5 DESCRIPTION OF PROPOSED EXPANSION

5.1 PROCESSING

Figure 5.1 Existing metallurgical processes

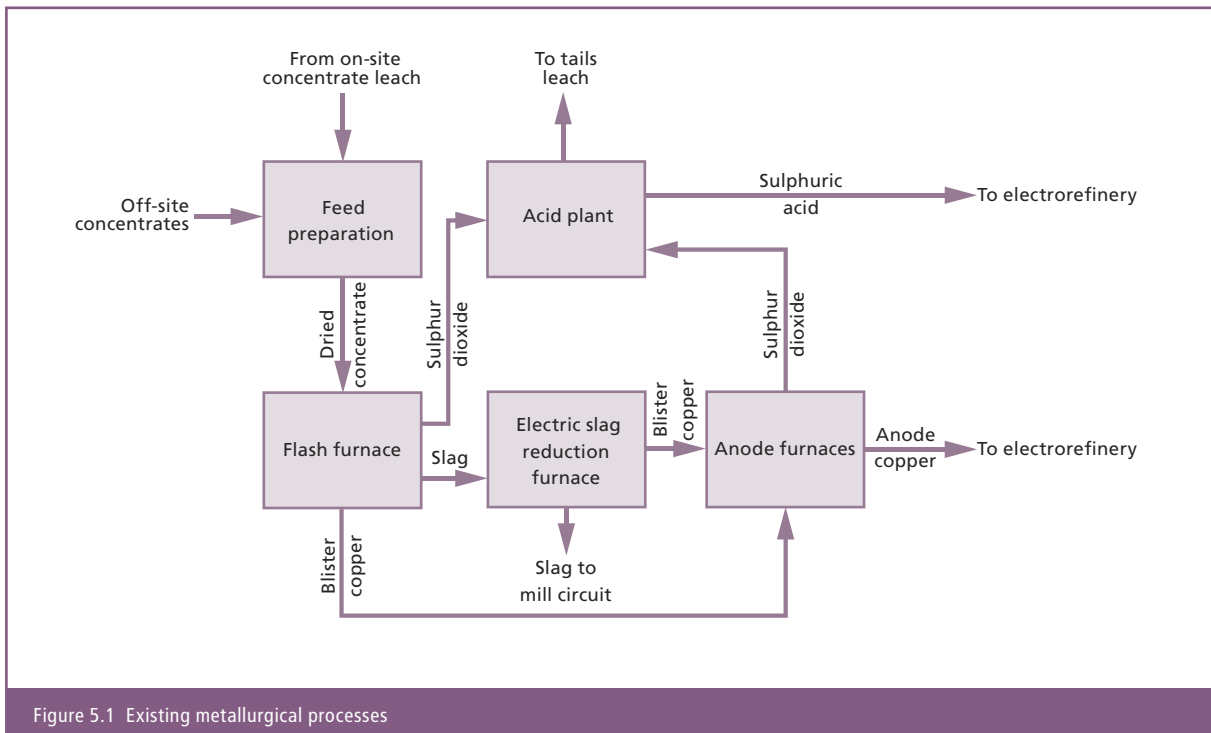
Further information was requested regarding the on-site processing of off-site concentrates, specifically related to the effect of these concentrates on the metallurgical process, potential volumes and methods of transport.

Figure 2.8 of the Draft EIS (a section of which has been reproduced here as Figure 5.1) outlines the existing metallurgical process. This process would not change in the event that concentrates generated off-site were processed at Olympic Dam. In particular:

- the sulphur in the off-site concentrate would also be transformed into sulphur dioxide (SO₂) and captured in the existing acid plant, where it would be converted into sulphuric acid for use in the hydrometallurgical areas of the processing plant, potentially offsetting demand for imported elemental sulphur

- there would be no additional tailings associated with the processing of off-site concentrate
- copper, gold and silver would be sent to the refinery as anode copper for conversion to anode slimes (containing gold and silver) and cathode copper (final product). Gold and silver would be subsequently extracted in the Slimes Treatment Plant and cast into bullion.

Figure 5.4 Indicative timing for tailings storage facility cell use

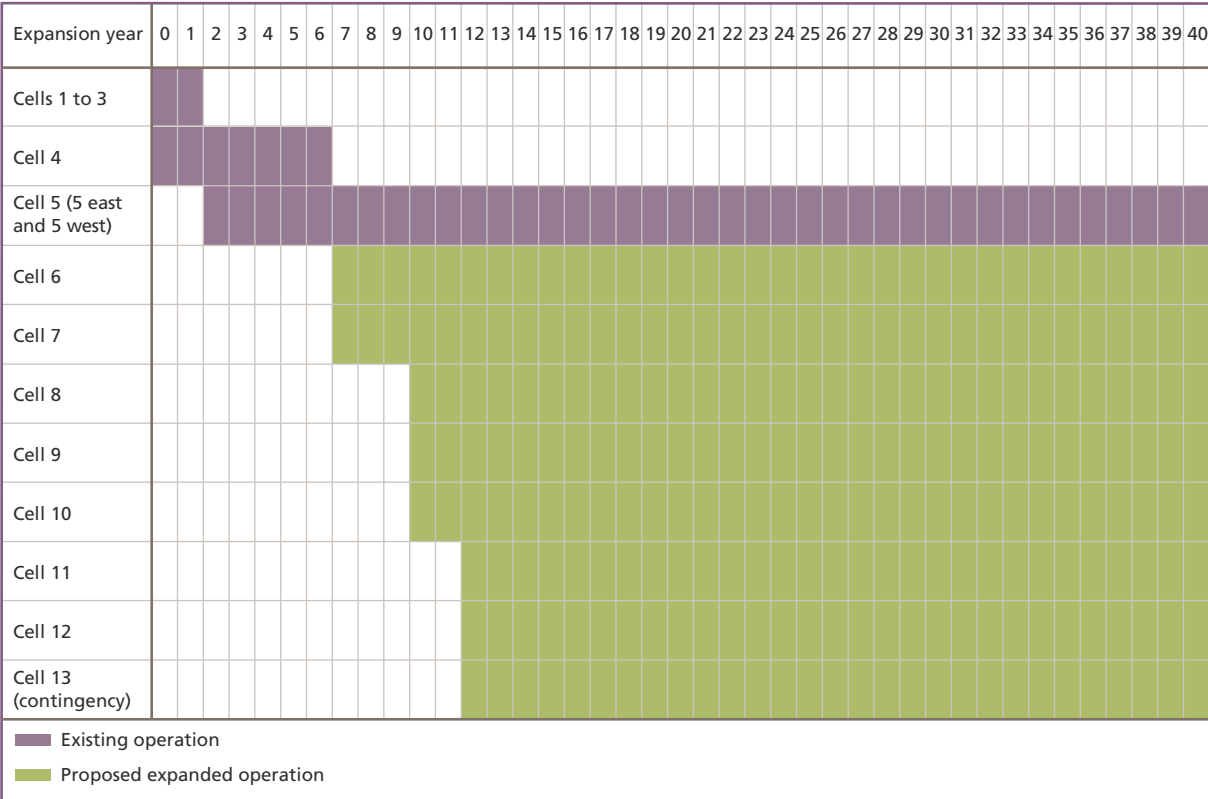
- the final height of the TSF and its stability, because some information presented in the Draft EIS noted heights of 40, 65 and 80 m
- the final overall outer embankment slope
- the dry density of the existing and proposed tailings
- the solids density target
- the design rate-of-rise
- the commissioning sequence for new TSF cells
- existing piezometers
- the volume of existing tailings production
- the estimated seepage rate of the existing and proposed TSF
- Figure 9.2 of Appendix F1.

In addition to the recently-approved TSF Cell 5, two TSF cells would be constructed initially, together with two balance ponds. Further TSF cells and balance ponds would be constructed to match the ramp-up in production until the full combined capacity of 72 Mtpa of ore throughput was reached (see Figure 5.4 of the Supplementary EIS for an indicative TSF commissioning schedule).

Figure 5.9 Stability analysis for the proposed 65 m high rockfill embankment tailings storage facility cells

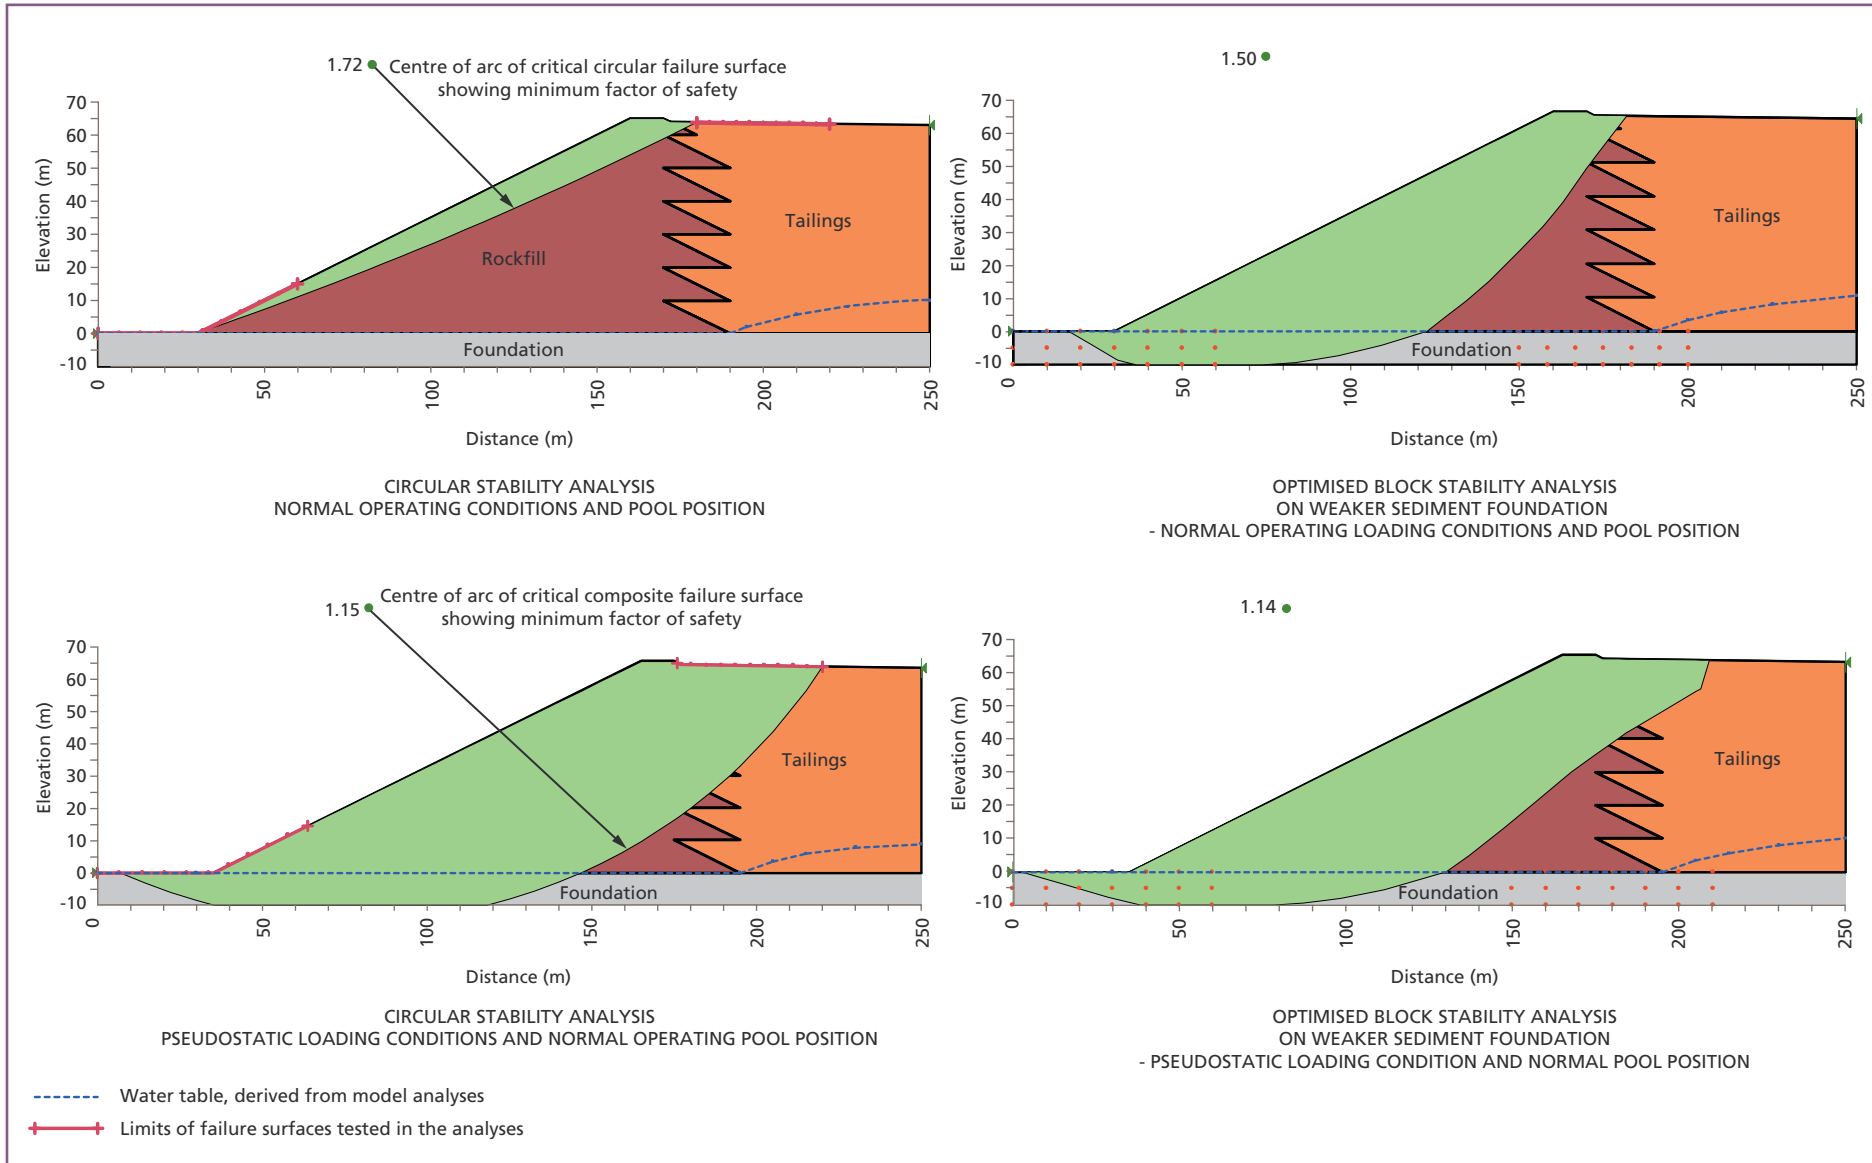
BHP Billiton acknowledges that there is a difference between the shear strengths and material properties presented in Table 7.4 and Figure 7.4 of Appendix F1 to the Draft EIS. The shear strengths presented in Figure 7.4 are incorrect.

To reaffirm the Draft EIS design conclusions, stability analyses (using GeoSlope 2007) have been conducted for the 65 m final height case, with the phreatic surface provided in Figure 5.8 of the Supplementary EIS and the design shear strength parameters listed in Table 5.5, which differs from Table 7.4 of Appendix F1 to the Draft EIS only in the allocation of a 5 kPa cohesion allowance for the sediment foundation shear strength.

The results of the revised stability analysis are summarised in Table 5.6, and the stability analysis outputs are shown in Figure 5.9. The correction to the cohesion allowance makes no material difference to the impact or risk assessment presented in the Draft EIS because a conservative assessment was undertaken and the upper boundaries assessed remain worst-case.

Figure 5.12 Desalination plant showing desalination sludge dewatering lagoons

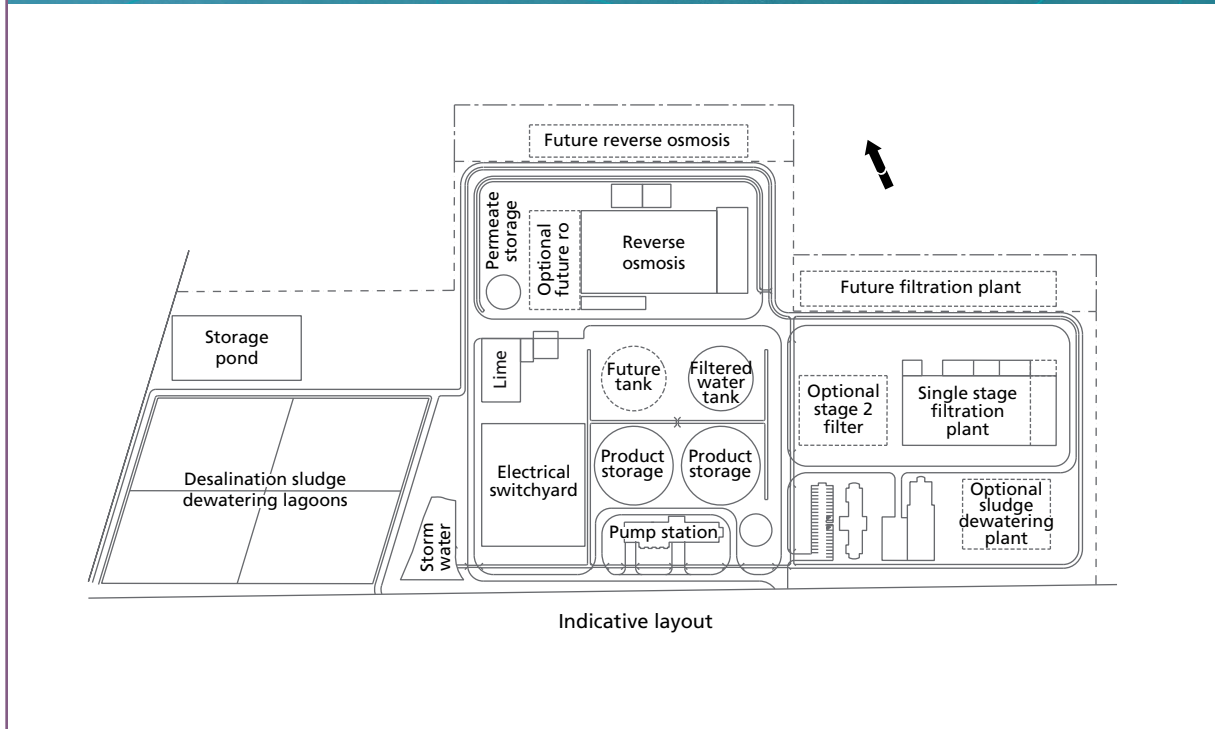
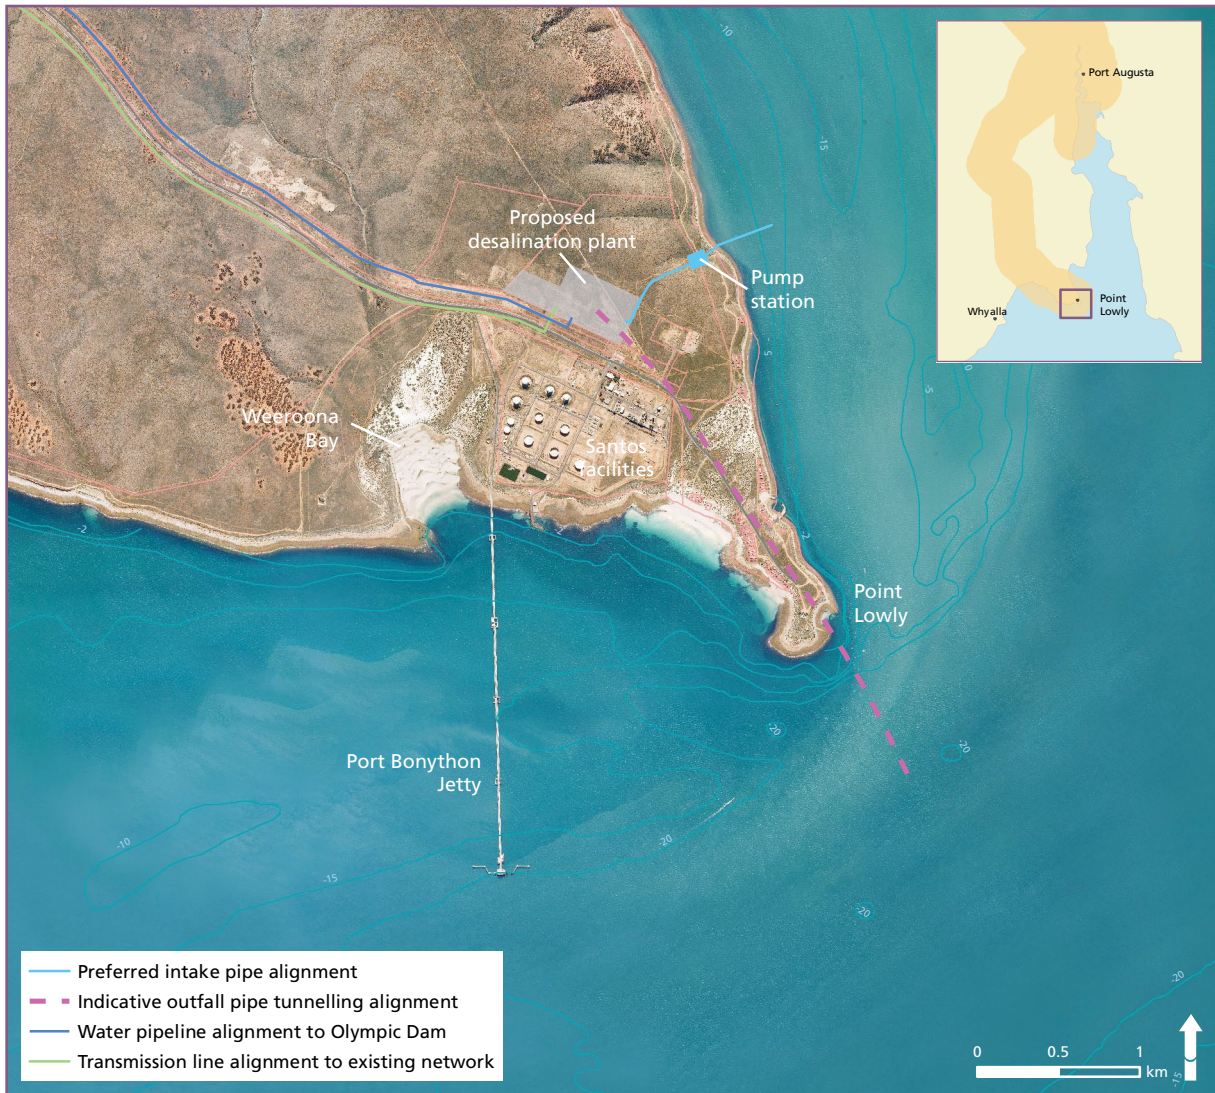
Clarification was requested about the volume of desalination plant backwash solids that would require land disposal, and whether there was any potential for further processing or use of the waste from the desalination plant to prevent or reduce the volume going to landfill. Clarifications regarding potential lagoon sizes and the potential for generation of odours were also sought.

If operated at the peak capacity of 280 ML/d (i.e. 200 ML/d for the Olympic Dam expansion plus the 80 ML/d allocated to government use) the proposed desalination plant would generate about 6,600 tonnes of backwash sludge per year from about 28.3 ML/d of backwash wastewater. The sludge would contain around 1,425 tpa of suspended solids (at 6 mg/L) and 2,965 tpa of ferric chloride (at 12.5 mg/L), together with around 50% residual water. The volumes and frequency of waste generation would change depending on the final waste management option chosen. Both the mechanical dewatering and sludge lagoon options would result in the generation of about 5,700 m³ of waste per year, however the mechanical dewatering waste would be disposed of weekly (approximately 110 m³ per week), whereas sludge lagoons would be emptied approximately every six months (with a volume of around 2,850 m³ per cycle).

As discussed in Section 13.5.3 of the Draft EIS, the backwash sludge has the potential to generate odour as a result of the decay of organic matter. However, maintaining shallow ponds with a high rate of water inflow and outflow, together with six-monthly sludge disposal, is expected to minimise odours. Mechanical dewatering, if chosen, would result in little or no odour being generated, based on the experience at other, similar facilities. As the final backwash management solution has not been chosen, the sludge lagoon design has not been finalised. However, at least two ponds with a capacity of at least 2,800 m³ would be required. At 1 m depth (shallow to encourage greater evaporation), the required area would be about 5,600 m², or approximately 75 m square, and each would be lined with a low-permeability material to prevent leaching from the ponds. The proposed location of the sludge lagoons was presented in Figure 5.30 of the Draft EIS, and is repeated here as Figure 5.12.

Disposal of the generated backwash sludge/solids would nominally be by truck to an appropriately licensed landfill facility, consistent with other recent desalination plant proposals. However, there exists some potential for beneficial reuse of the sludge material, particularly as a substitute construction material/fill, landfill cover material or as organic fertiliser. BHP Billiton would welcome the opportunity to discuss these options further with interested parties.

Figure 5.13 Indicative location of the on-site desalination plant and rock storage facility

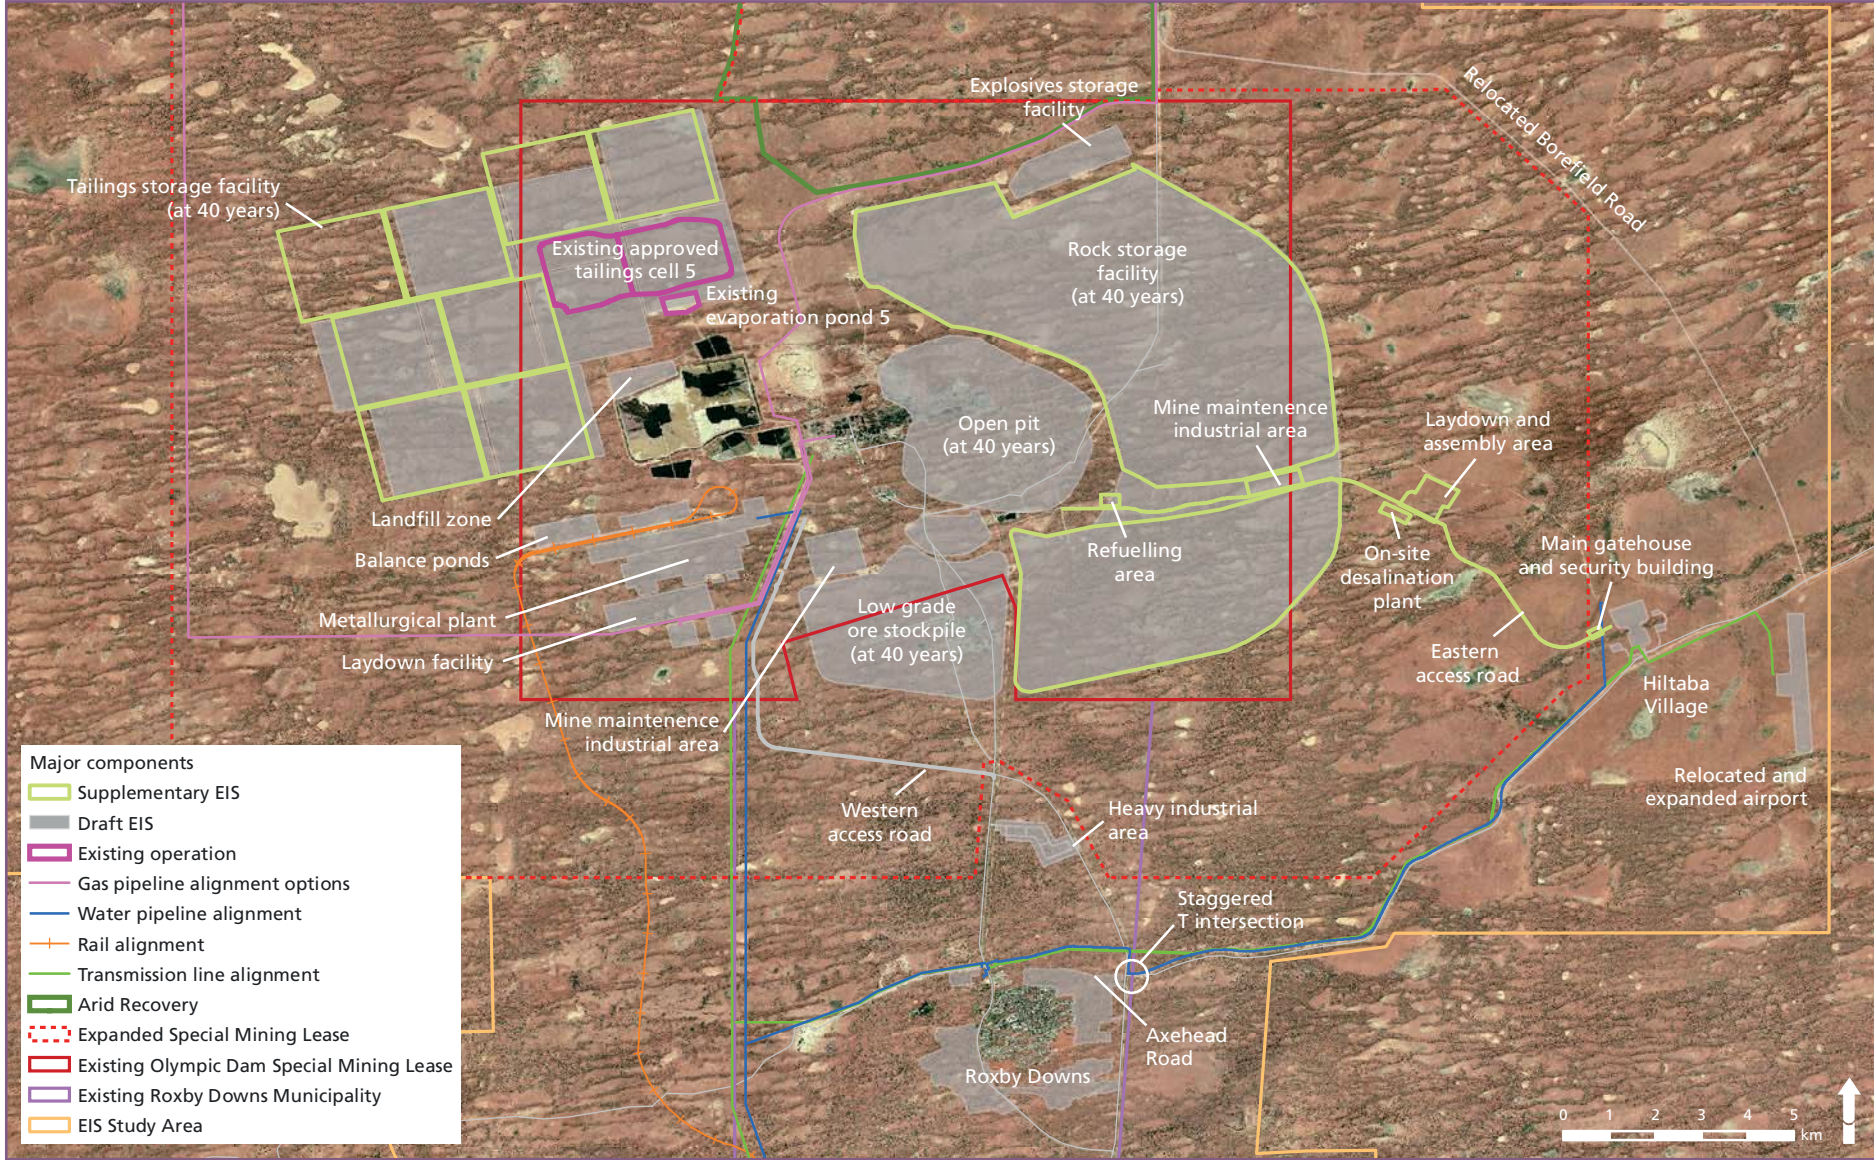
It was requested that the location of the new on-site desalination plant be confirmed in the Supplementary EIS to ensure it is not affected by the location of the RSF. Clarification on the operation of the on-site desalination plant and the management of the brine generated from the plant was also requested.

The location of the proposed relocated on-site desalination plant was shown in Figure 5.12 of the Draft EIS. This figure, together with the addition of the proposed RSF boundary, is reproduced here as Figure 5.13. This location would maintain connection to the borefield pipeline with minimal new pipeline installation required. After the new on-site plant had been commissioned, the existing plant would be decommissioned and removed.

As with the existing plant, the new plant would continue to supply about 14 ML/d of desalinated water to the operation and regional users, with the brine generated from the reverse osmosis desalination process being added to the remaining GAB extraction to form 'process water' for use in the processing plant where high-quality water is not required. No permanent on-site or off-site disposal of brine from the new plant would be required.
